TC1775

32-Bit Single-Chip Microcontroller

TC1775 Documentation Addendum

Revision History: **2001-10**

DMU_CON
DMU Control Register **Reset Value: 0000 0000_H**

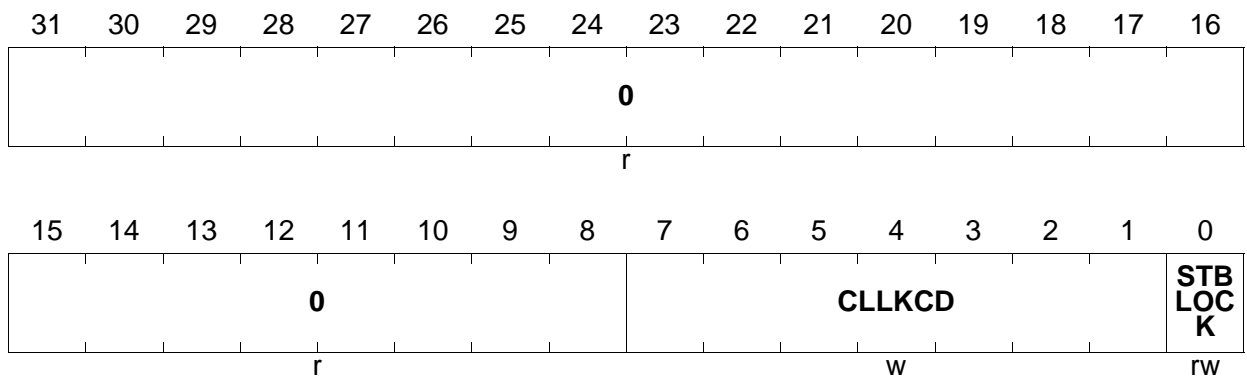
Page 9-11

The description of register DMU_CON must be corrected in the following way:

Field	Bits	Type	Description
STBLOCK ¹⁾	0	rw	Lock Standby Data Memory Bit can be set by writing a 1 to it (in supervisor mode only). Bit can only be reset (in supervisor mode only) by writing a 0 to it together with the appropriate clear lock code. 0 Normal operation of standby data memory 1 Standby data memory is locked. No read or write access of/to standby SRAM is possible. The state of STBLOCK after power-on reset is undefined. A hardware or software reset does not effect this bit.
CLKCD	[7:1]	w	Clear Lock Code This bit field has to be written with 65 _H together with STBLOCK = 0 to reset the lock of the standby RAM.
0	[31:8]	r	Reserved ; read as 0; should be written with 0.

¹⁾ This bit field is not available in the TC1775 BA11 step.

Figure 12-6 Basic Read Access Timing in Demultiplexed Mode

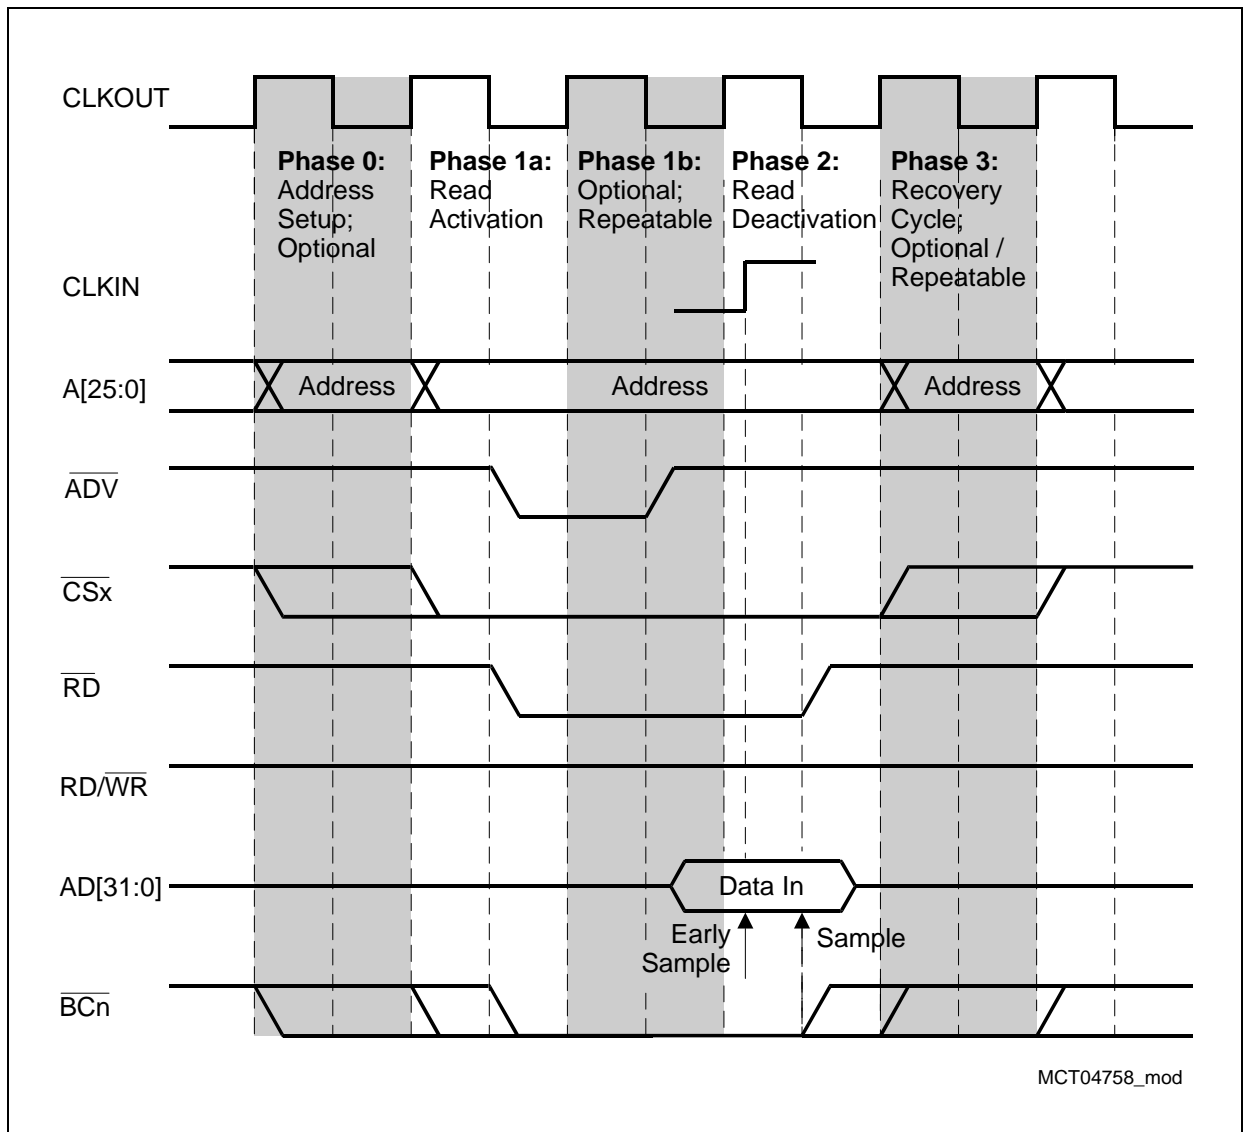
Page 12-21, 12-22 (Figure 12-6), and 12-62

The TC1775 provides an additional demultiplexed read timing feature called "Early Sample". This feature is shown in the corrected **Figure 12-6** and controlled via bit 26 (called ES for "Early Read Sample Select") in register EBU_BUSCONx. EBU_BUSCONx.ES must be added as described on **Page 9**).

Due to this new feature, the paragraph starting with "Phase 2: ..." on page 12-21 must be replaced by the following description:

- "Phase 2: This cycle is always part of a read access. Please note that the read signal is deactivated (high) on the falling edge of CLKOUT. The data input is sampled and latched with this clock edge (EBU_BUSCONx.ES = 0) or with the rising edge of CLKIN when early sample is enabled with EBU_BUSCONx.ES = 1."

Figure 12-16 EBU Boot Process after Reset

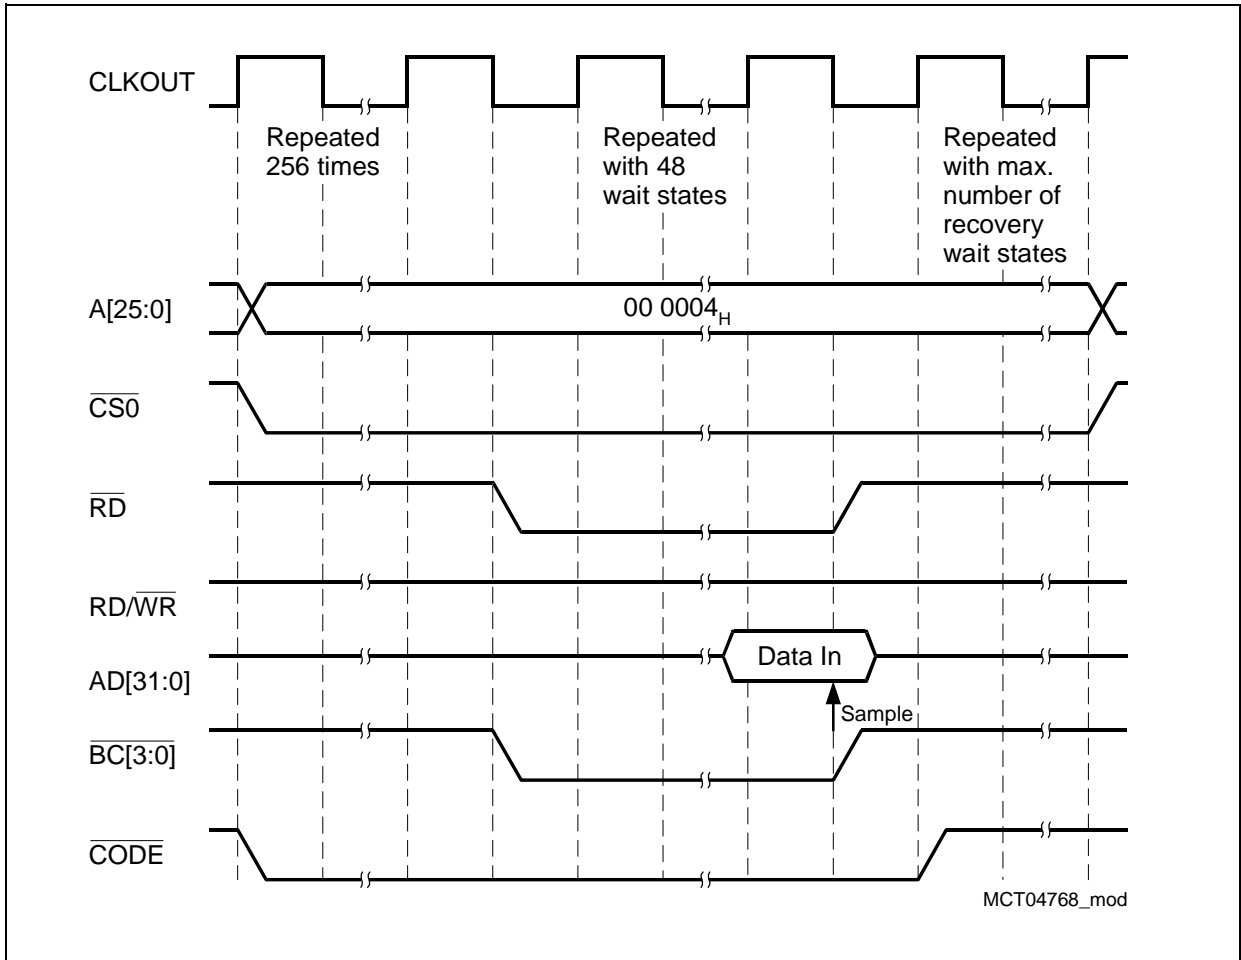
Page 12-44, Update of Figure 12-16

Figure 12-16 should be update with the following drawing:
